Public Works Project No. 89006007-23-034-C1

I-70 WB Centerville Welcome Center  
INDOT

**ADDENDUM NO. 1**

October 1, 2024

Revision:	ADDENDUM #1 10/1/24
Project Number:	89006007-23-034-C1
Requestion Number:	
Account Number:	
Designer:	IID
Drawing Date:	8/30/2024
Drafter:	JC
Drawing Scale:	1"=5'
DAPW Approval:	
Client Approval:	
Reference Number:	1394
Building Reference:	
Drawing Number:	C104
Sheet:	12 of 140

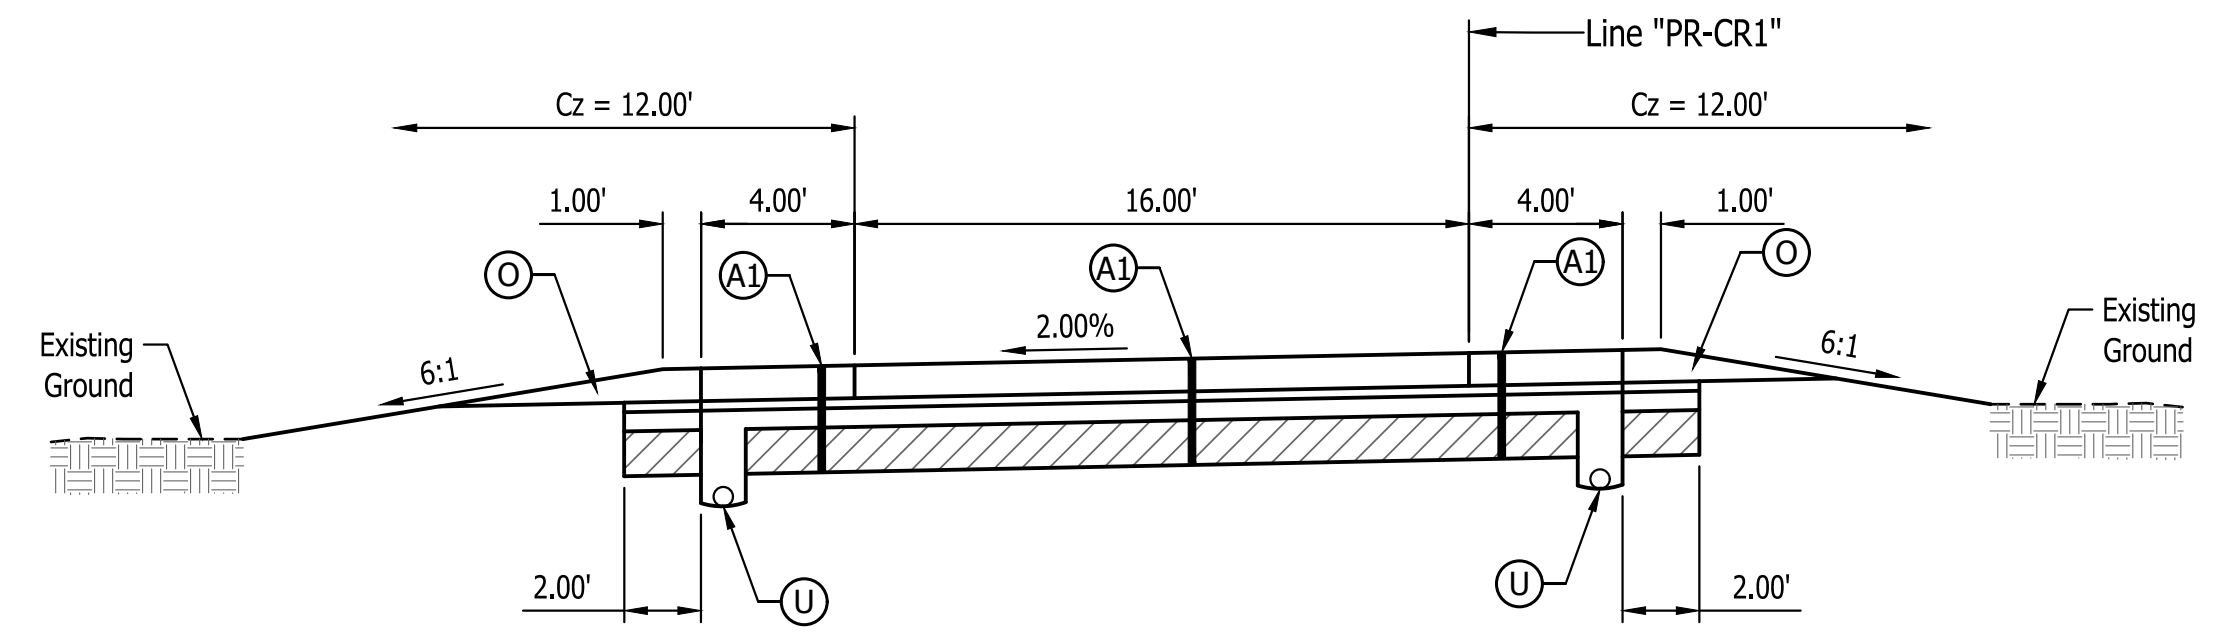
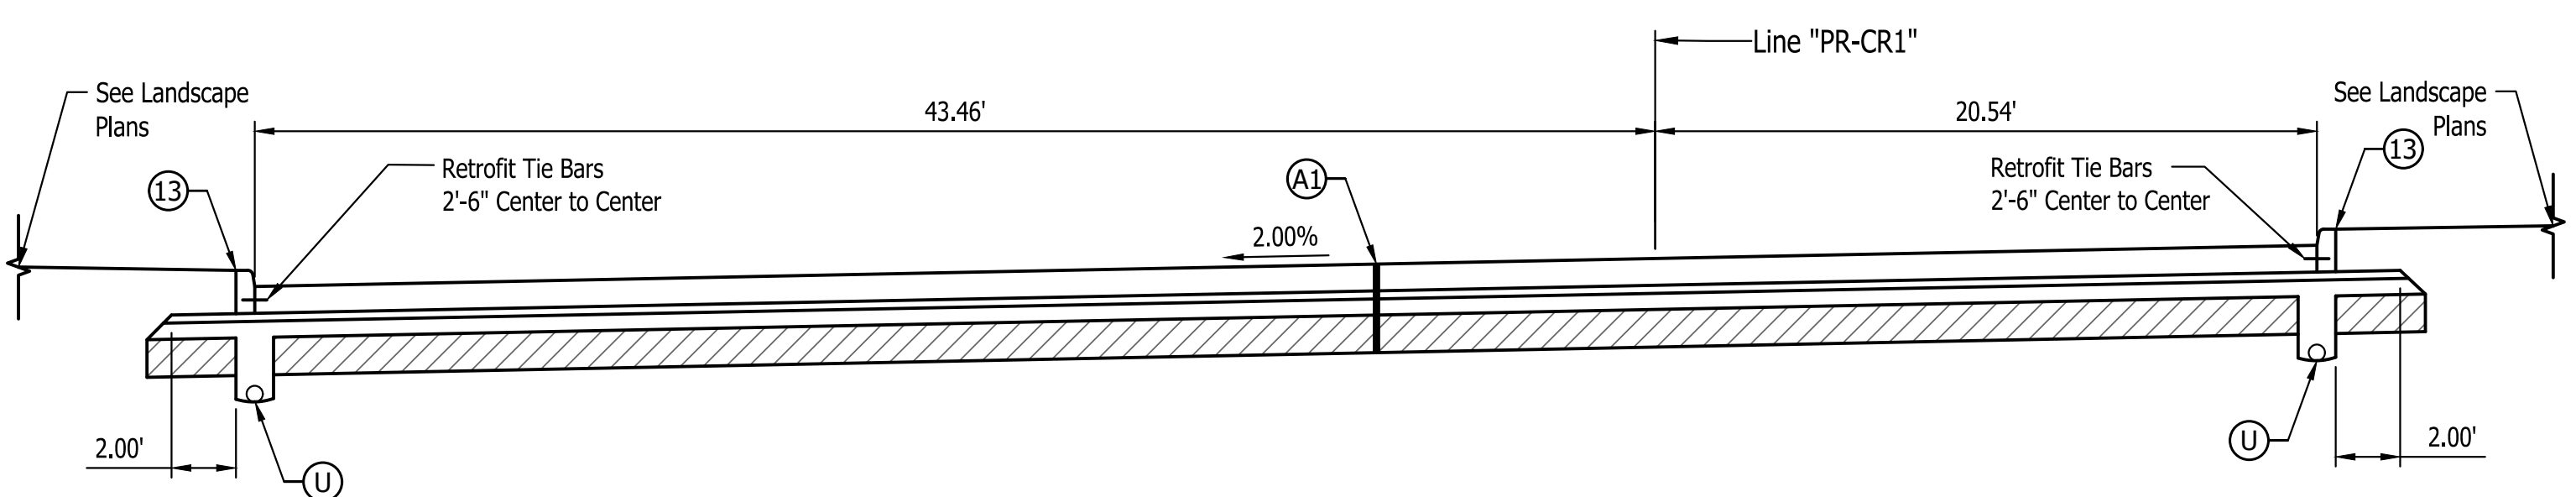
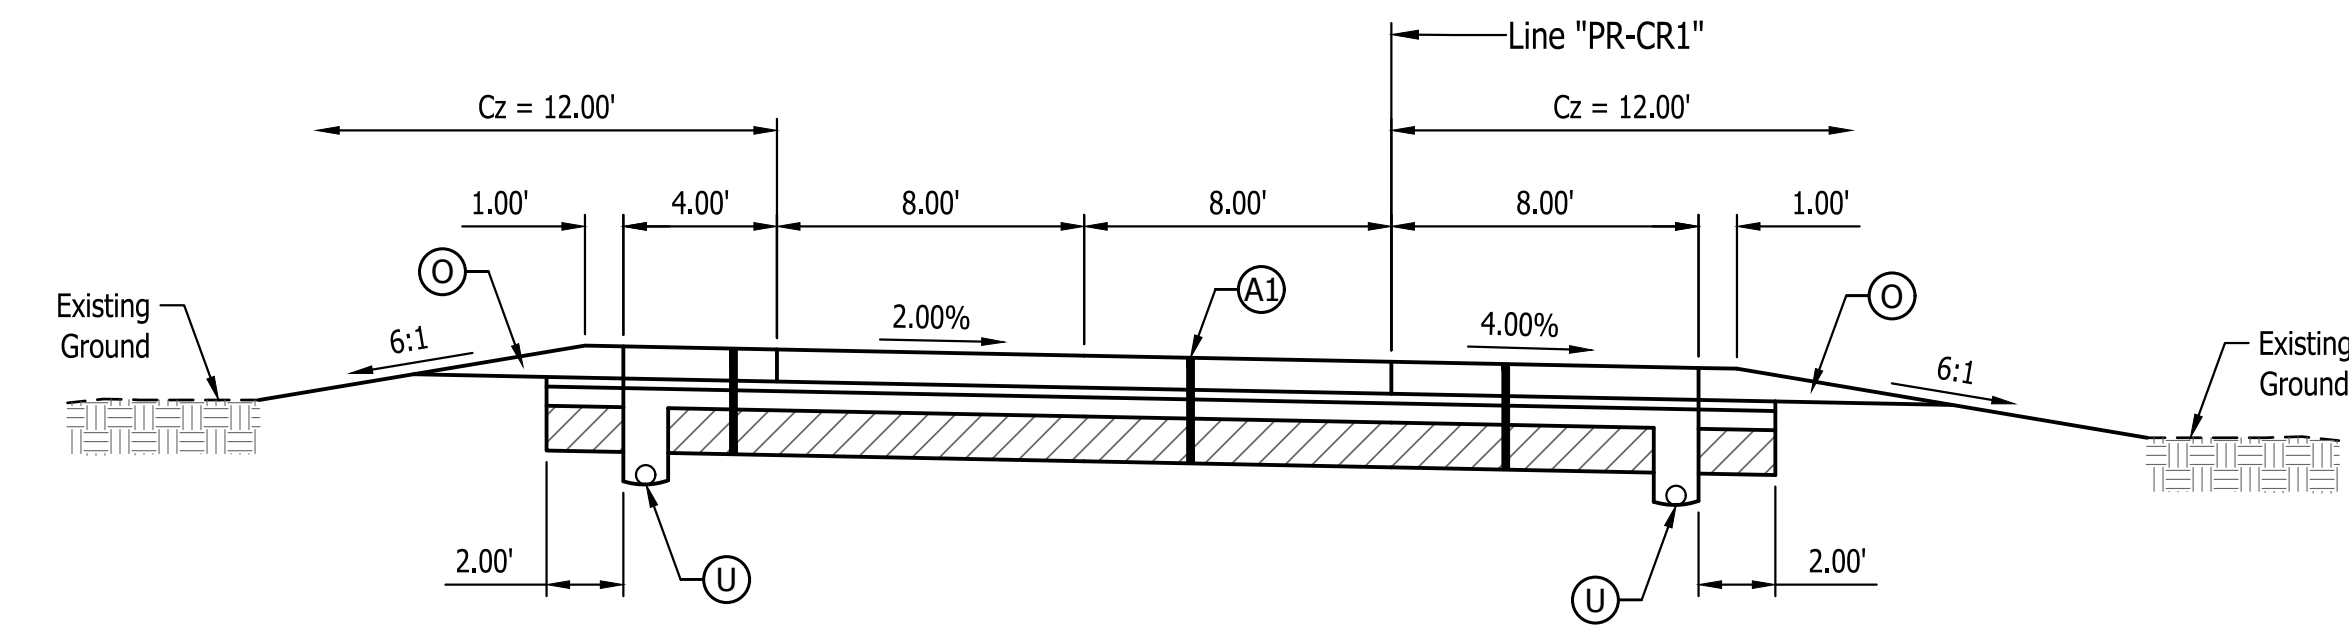
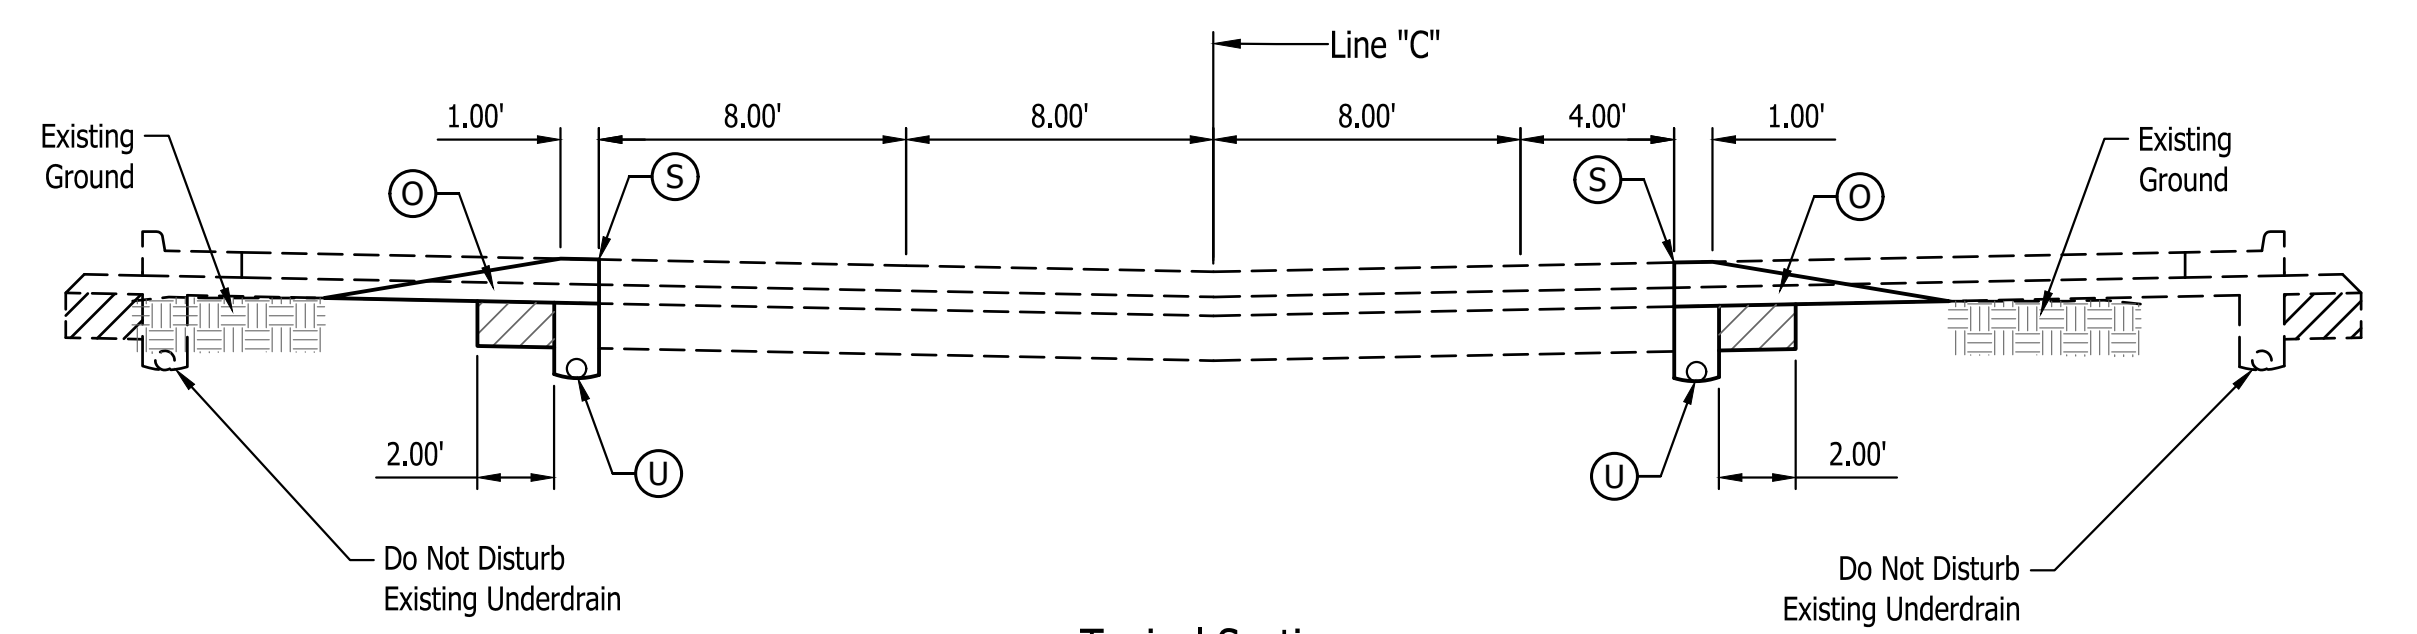
- Item No. 16-A1:**                    Drawing Set #5, Sheet C104  
Replace:                    Replace Sheet C104 with attached Sheet C104  
Revised Legend Items A and A1 per revised pavement design due to change in  
INDOT Binder Specifications.

Drawing Number: C105

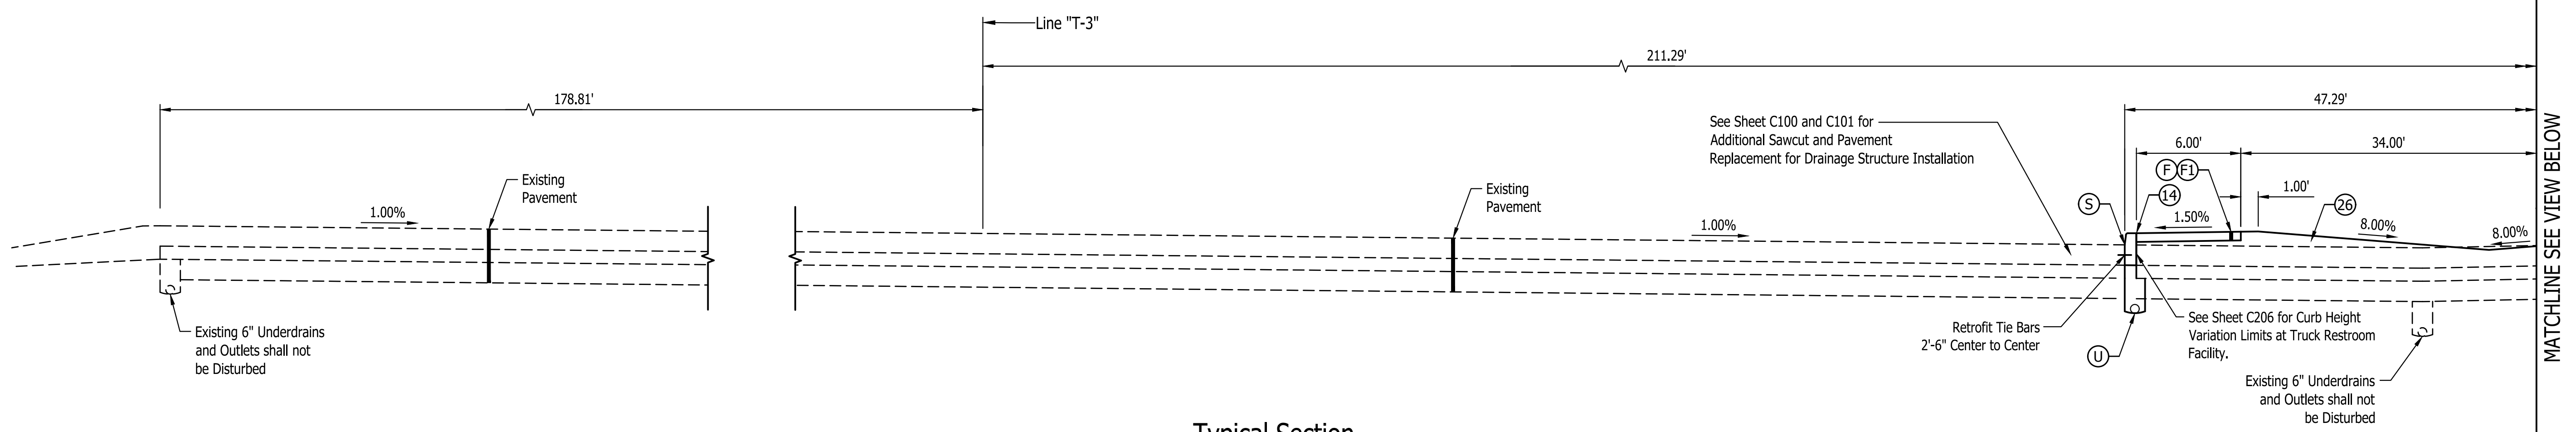
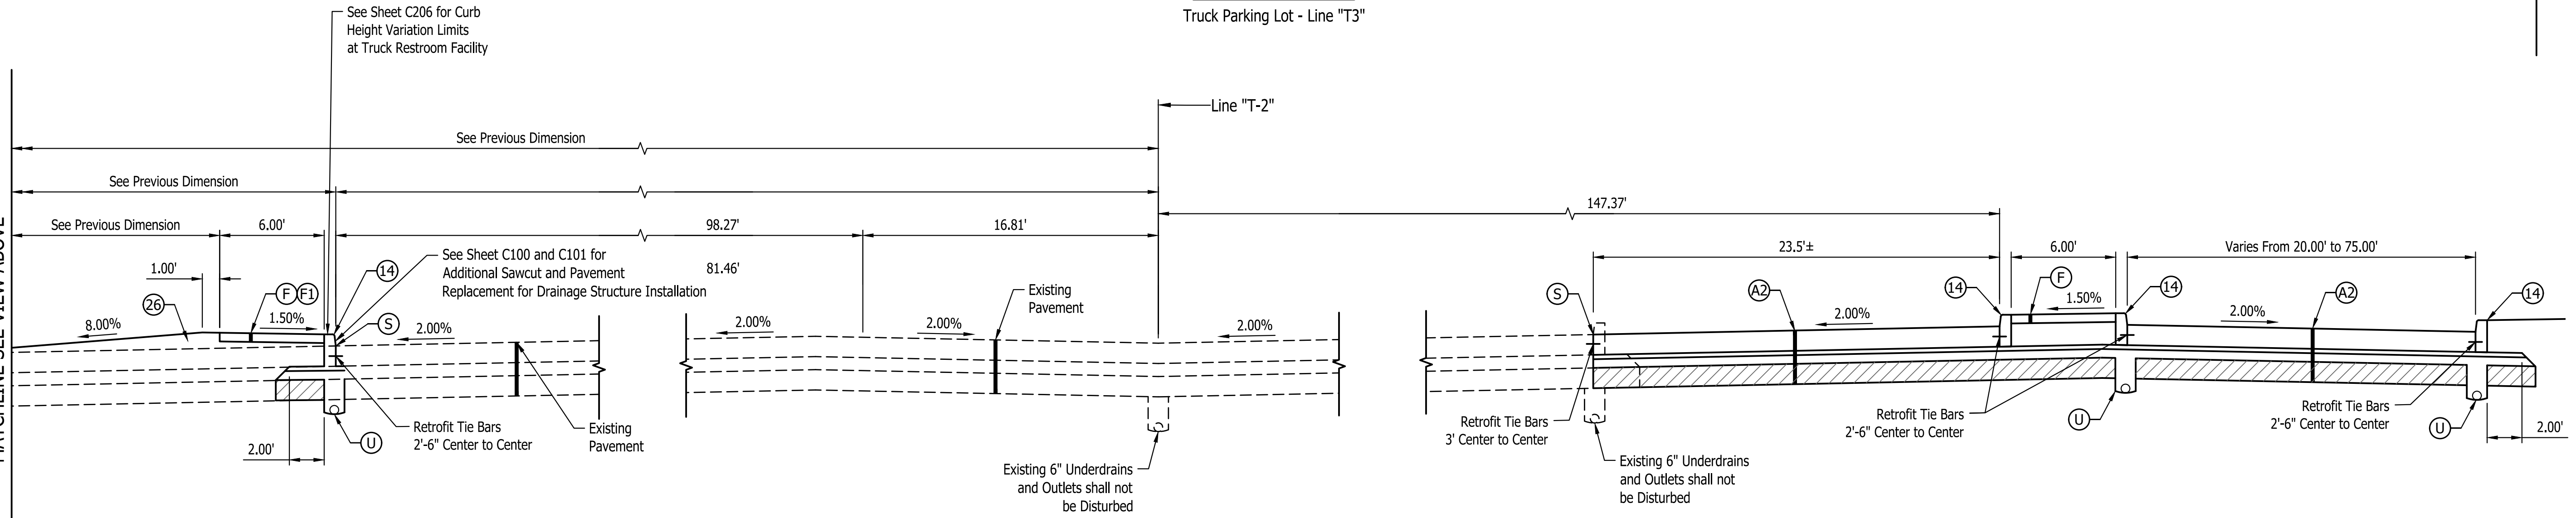
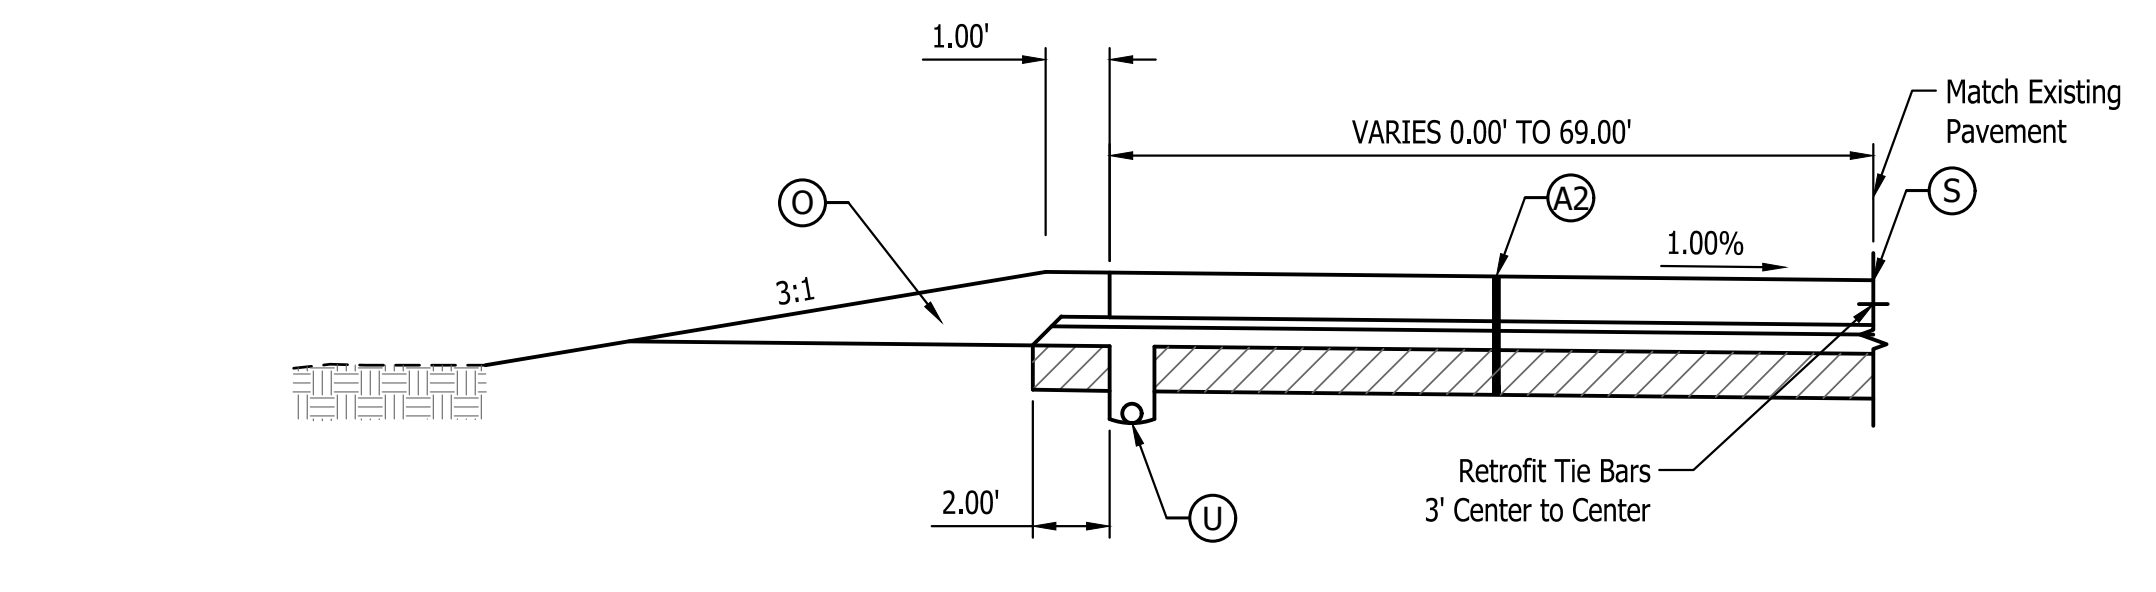
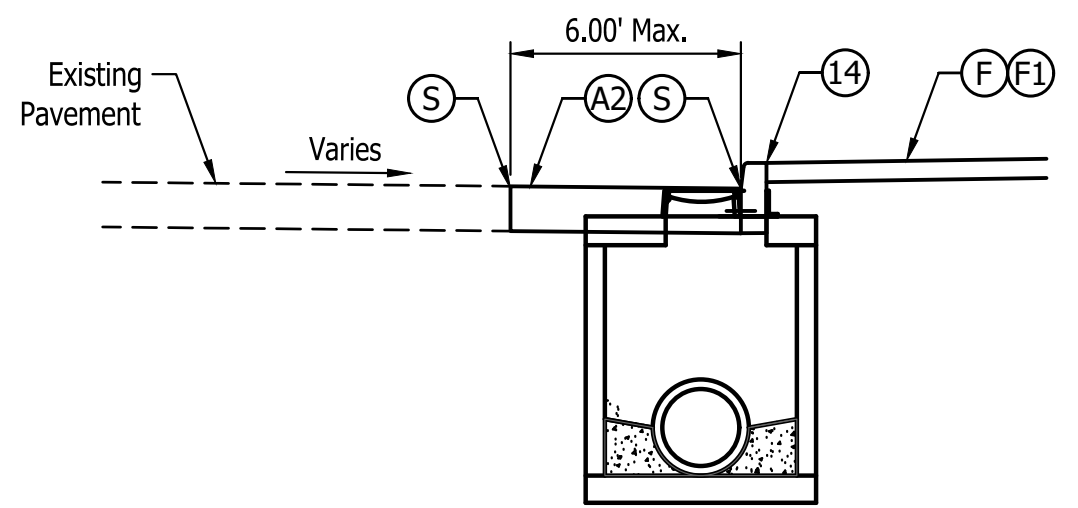
- Item No. 17-A1:**                    Drawing Set #5, Sheet C105  
Replace:                    Replace Sheet C105 with attached Sheet C105  
Revised Legend Items A and A1 per revised pavement design due to change in  
INDOT Binder Specifications.
